Ordinary Council Meeting - 17 June 2024

PS ref: 6771

**SAT APPEAL – BYFORD MIXED COMMERCIAL CENTRE - RESPONSE TO s31 CONDITIONS  
 LOT 806 SOUTH WESTERN HIGHWAY, BYFORD**

**SITE PLAN - RETAINING & LEVELS**

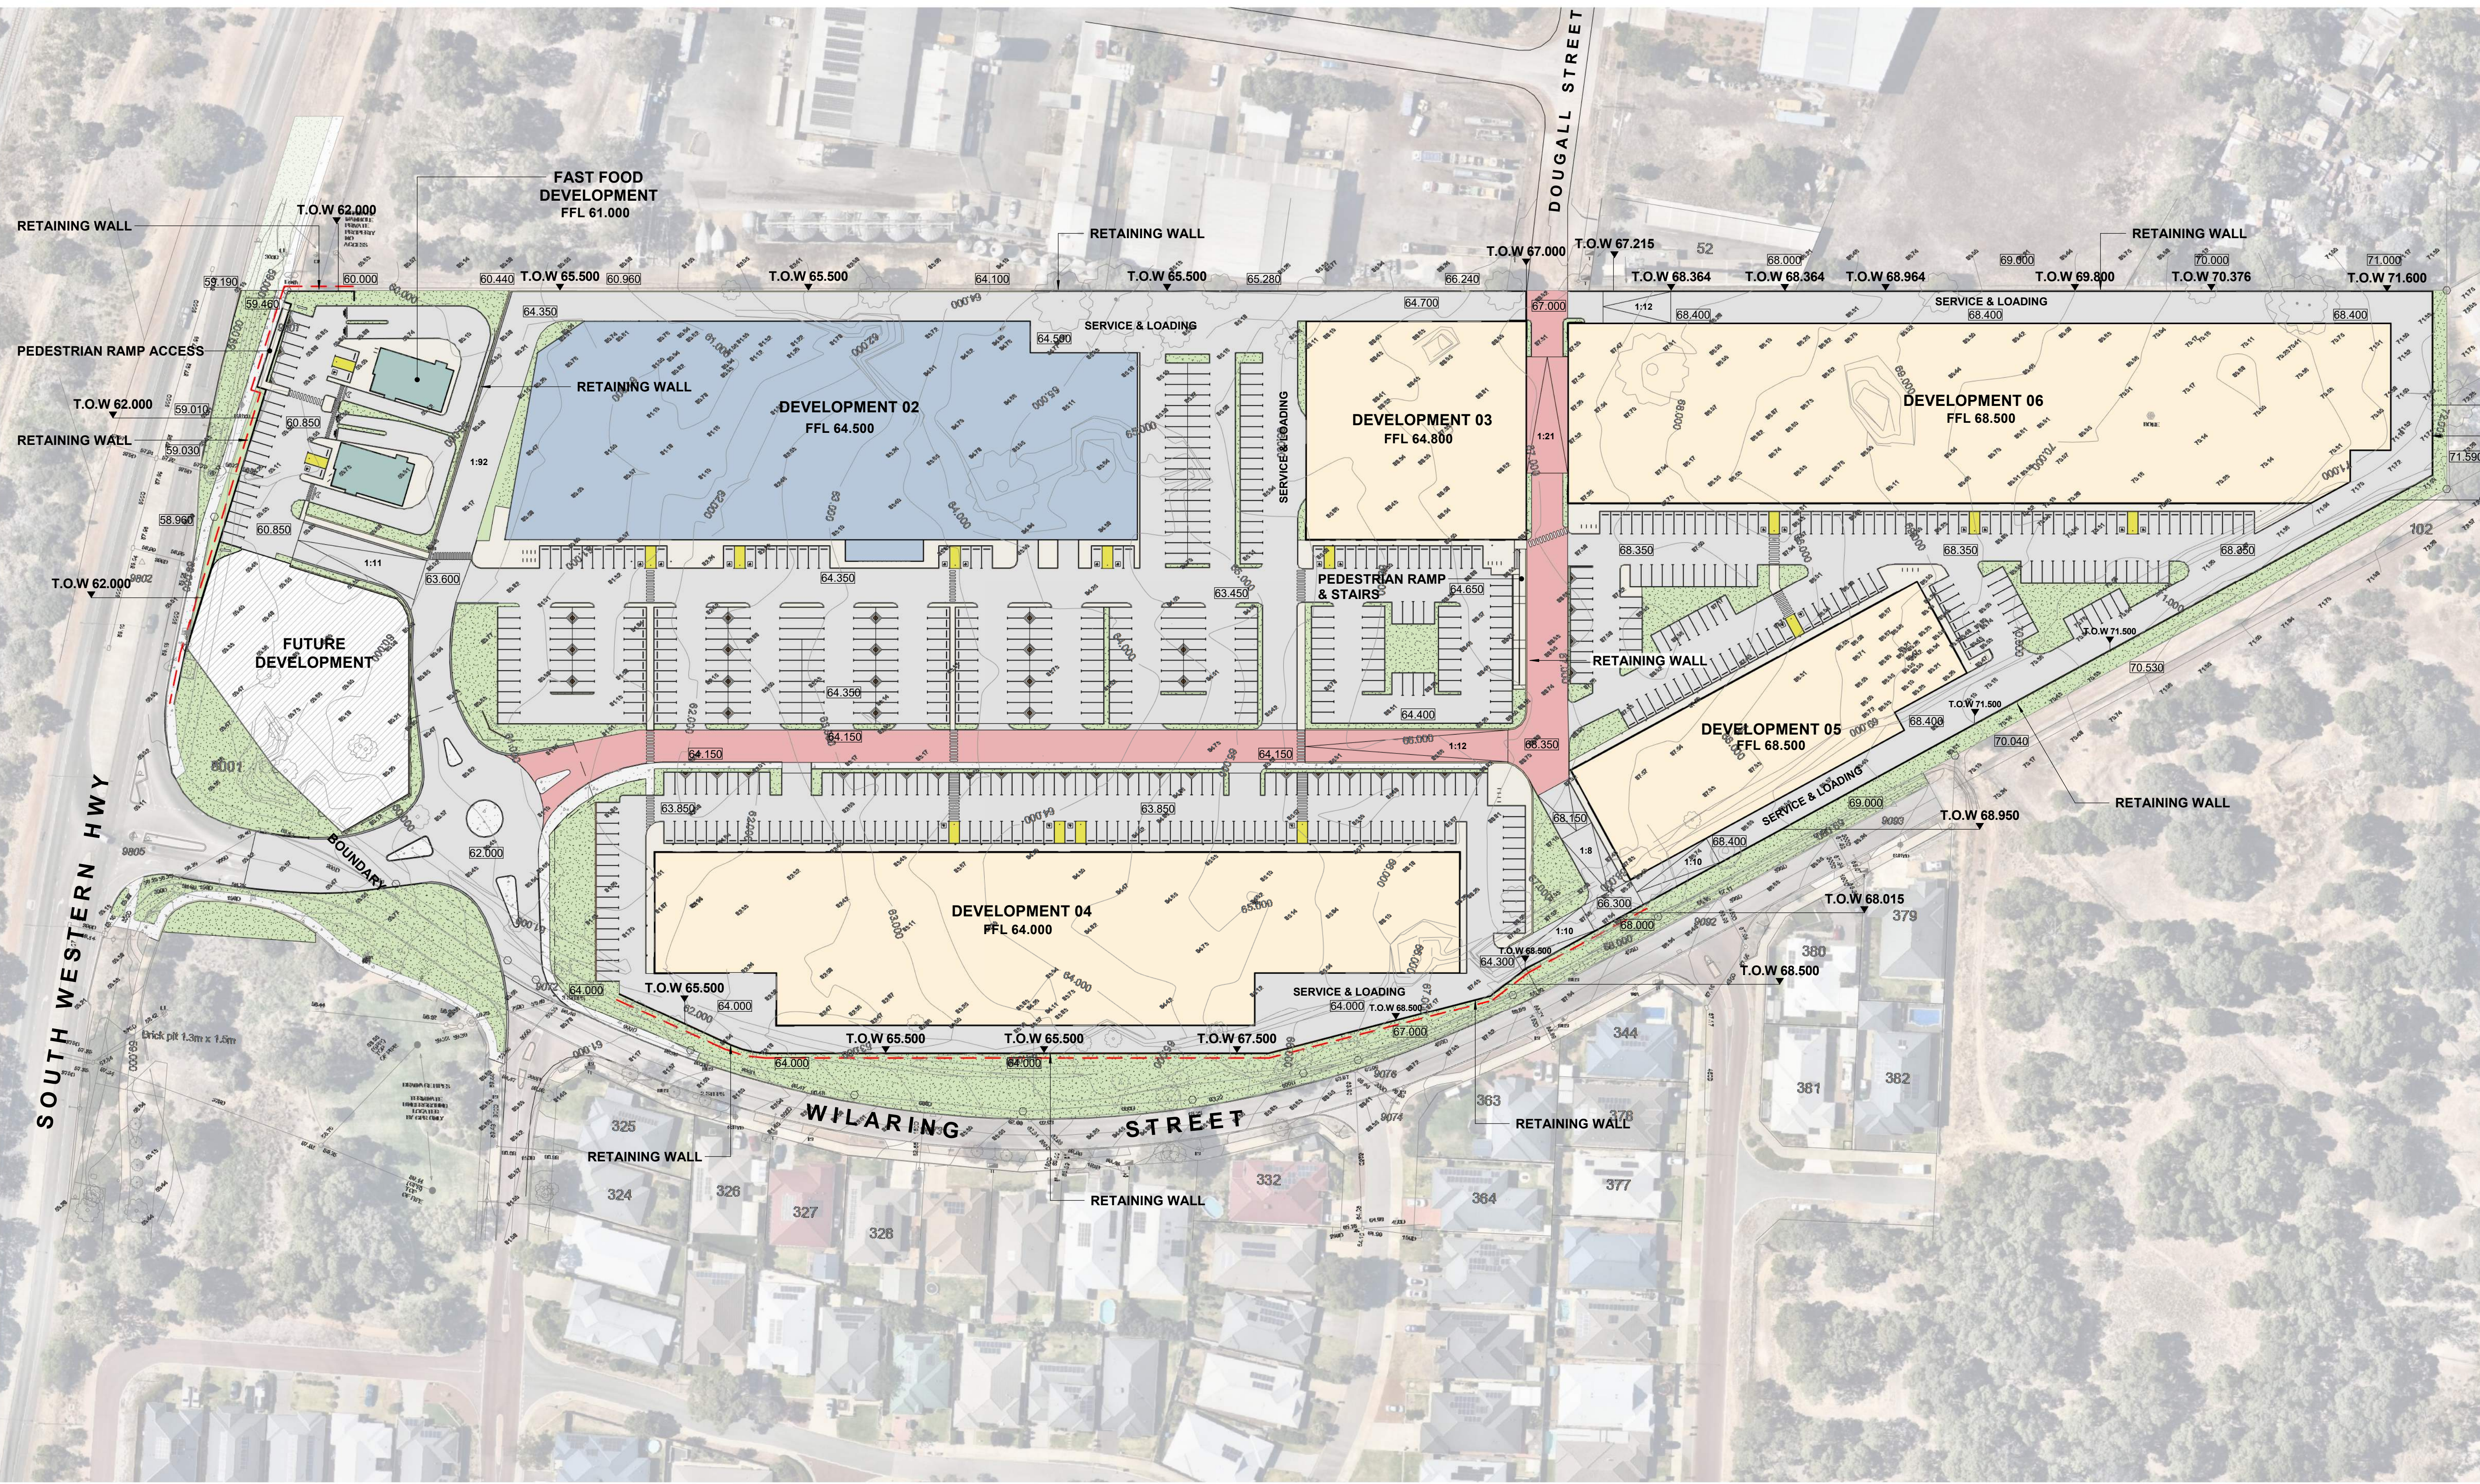
In response to condition 1b(ii), we have amended the materiality of retaining walls along the western boundary to include more earthy toned coloured limestone blocks. This is in accordance with the advice of the Shire, who sought to have the retaining walls complement other development in the area, with a focus on rammed earth blocks or coloured limestone. The retaining walls fronting Wilaring Street have also been modified to detail the change in colour, which will compliment to overall built form of the development. Refer **Figure 1 above and Figure 2** below, demonstrating the change in colour of the retaining.

**NOTE:**  
 ---  
 RED DASH INDICATES RETAINING WALL  
 VISIBLE TO SOUTH WESTERN HIGHWAY &  
 WILARING STREET TO BE AN EARTH TONE  
 COLOUR AS PER EXAMPLE IMAGE BELOW

**FF2 - NORTH ELEVATION**

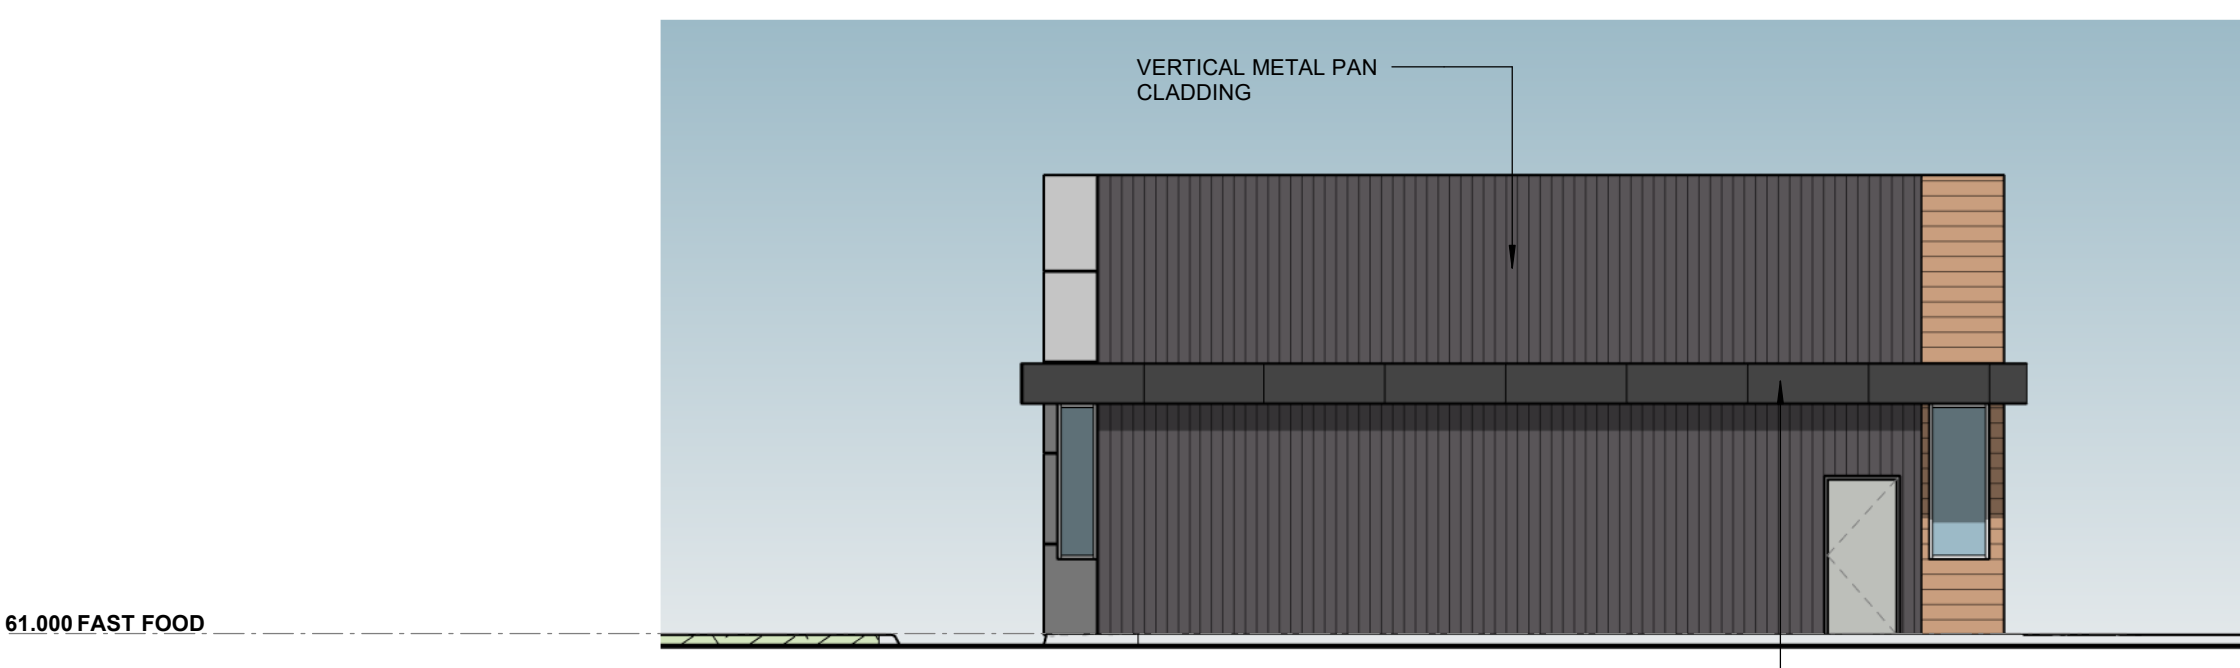
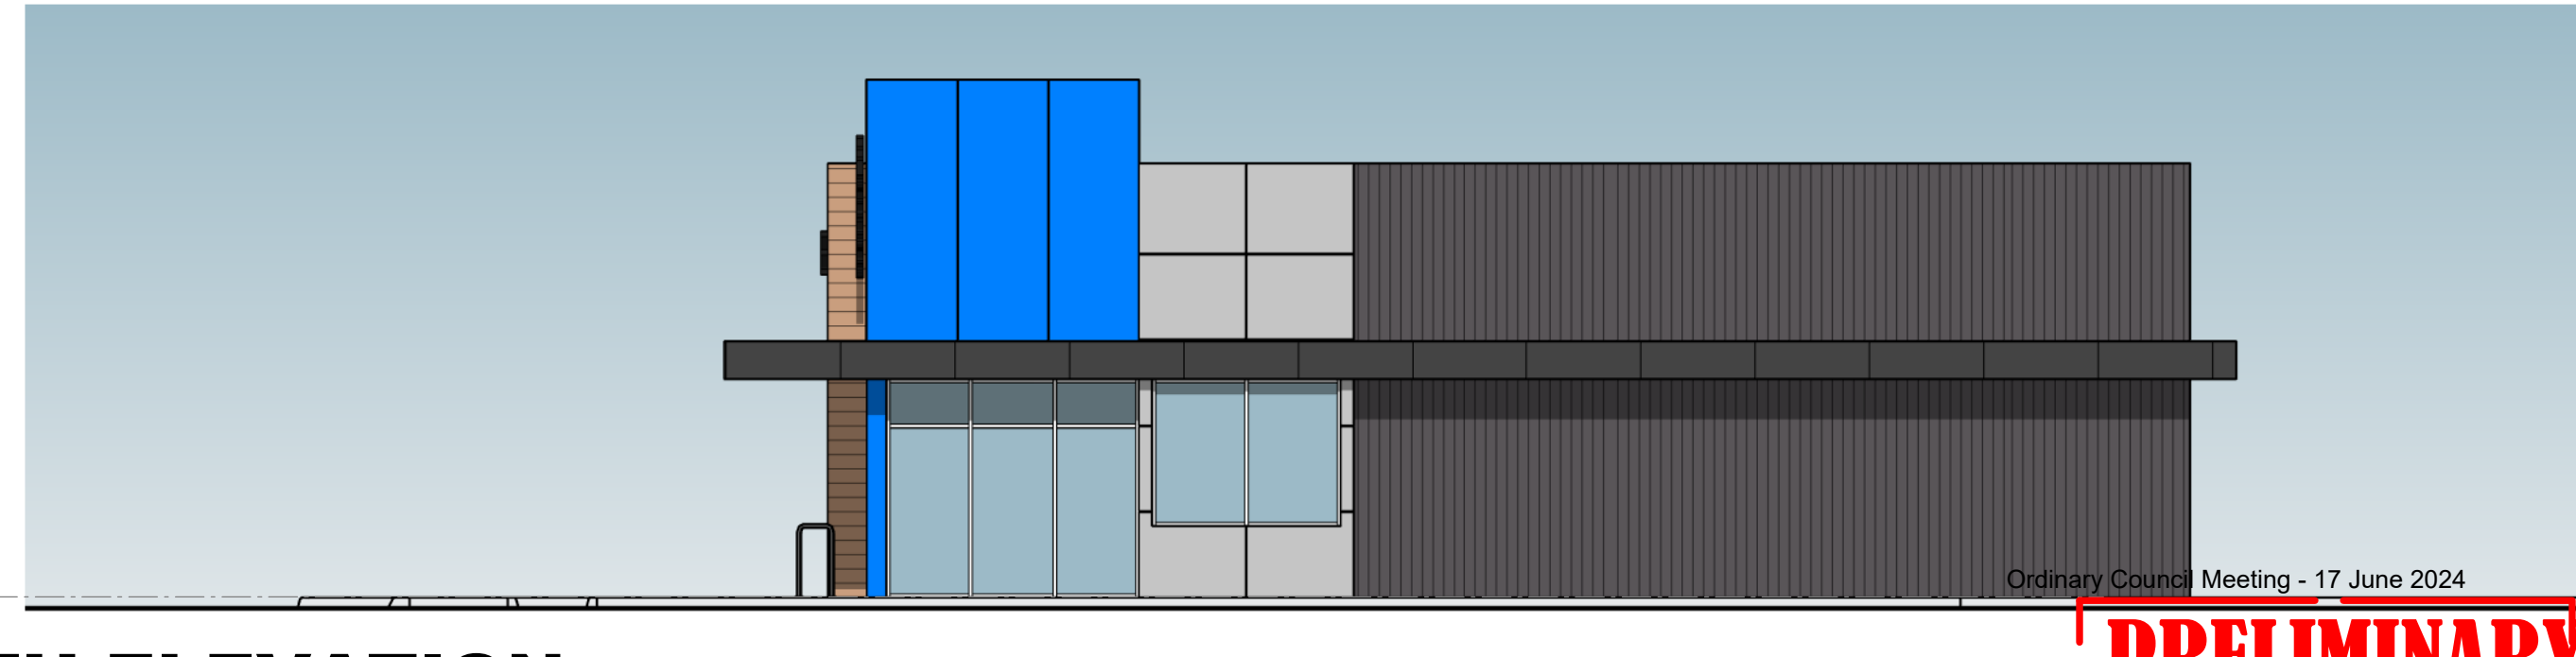
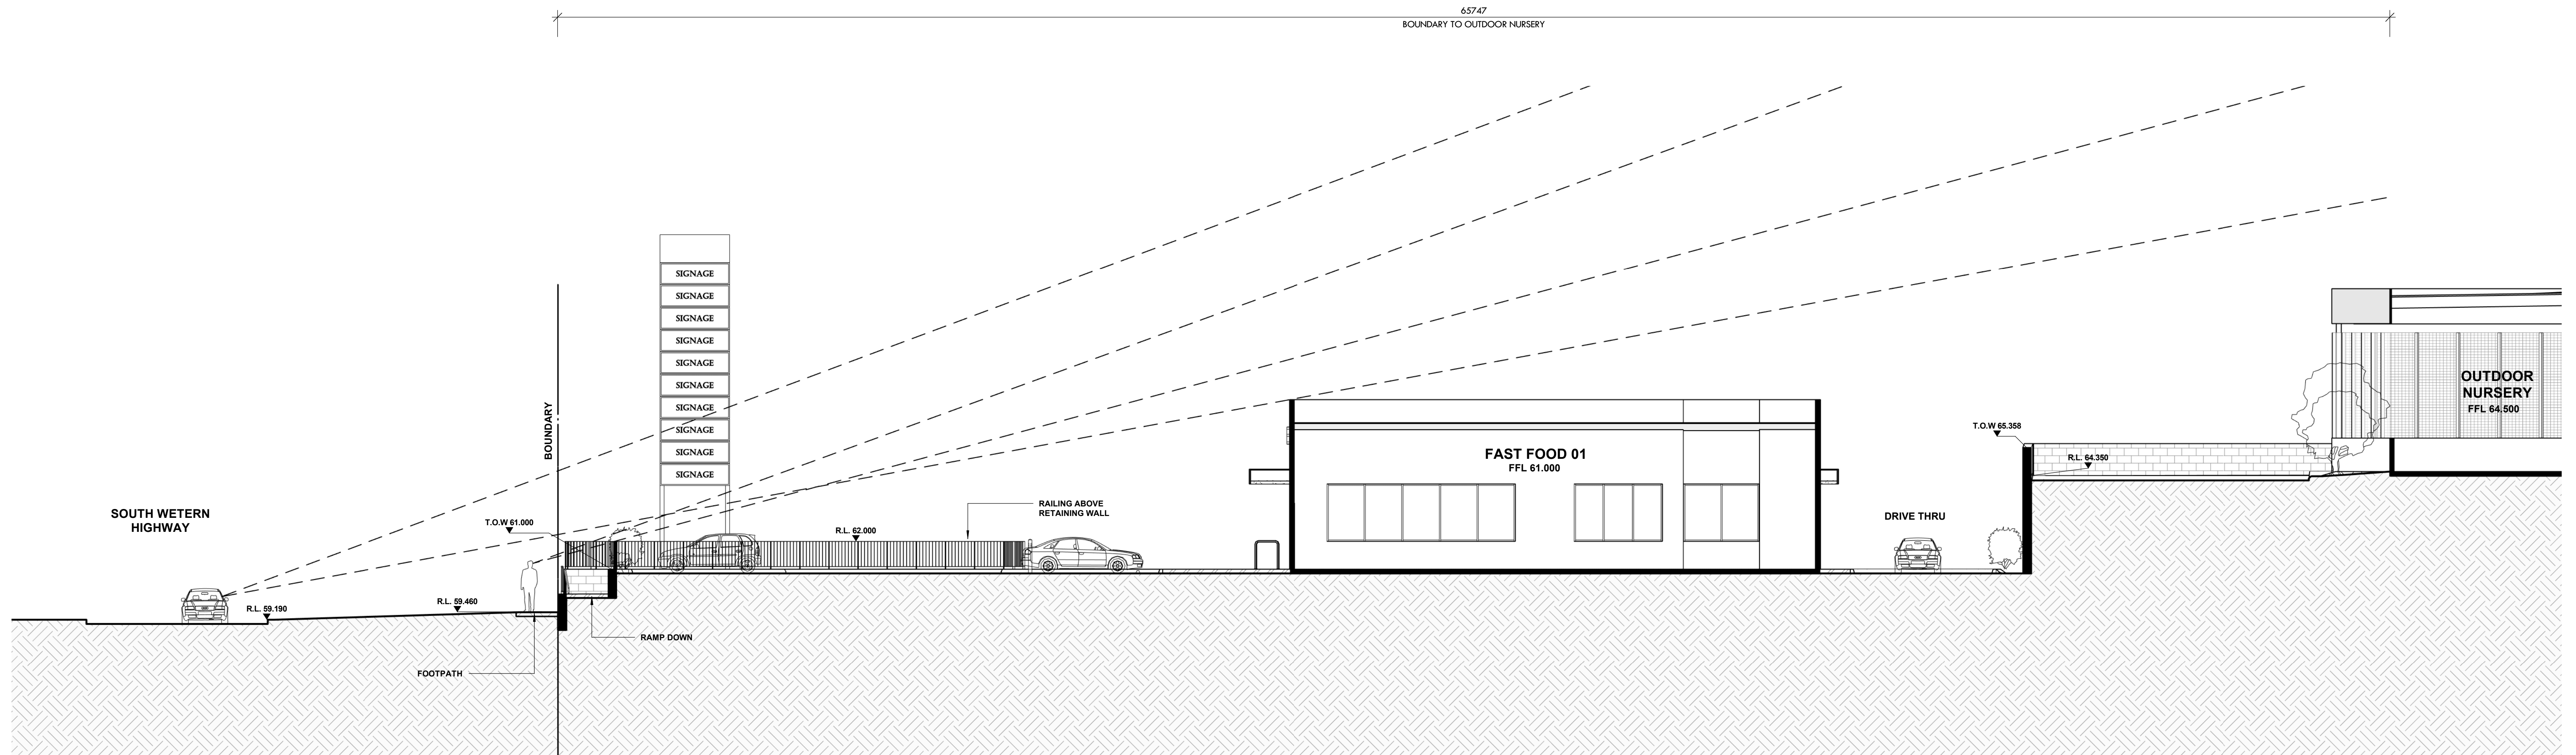
Condition	Approved Condition	Requested Changes to Condition
1b(i).	Amended elevations of the western facades of the 'Fast Food 01' and 'Fast Food 02' buildings to the west of site. This amended elevation should include amended design elements, materials and colours, that reflect the rural tones of the locality.	<b>Remove condition.</b> Amended development plans provided.  Refer additional justification below.
1b(ii).	Amended elevations of the western face of 'Development 02' building. This amended elevation should include amended design elements, materials and colours, that reflect the rural tones of the locality.	<b>Remove condition.</b> Amended development plans demonstrate the design of this façade. It was recognised this building façade is setback from the street and will be partially obscured by other development on the site.
1b(iii).	Amended development plans shall be provided including staggering and rendering treatments to the retaining wall on the west boundary of the site, to the satisfaction of the Shire of Serpentine Jarrahdale.	<b>Remove condition.</b> Amended development plans provided.  Refer additional justification below.

Accordingly, we have amended the development plans to further refine the built form and materiality of the buildings, in accordance with the intent of the condition. Specifically, the plans have been amended to:

- Timber like horizontal wall cladding to replace CFC cladding.
- Amend the colour of the retaining walls along South Western Highway to include a darker earthy tone.
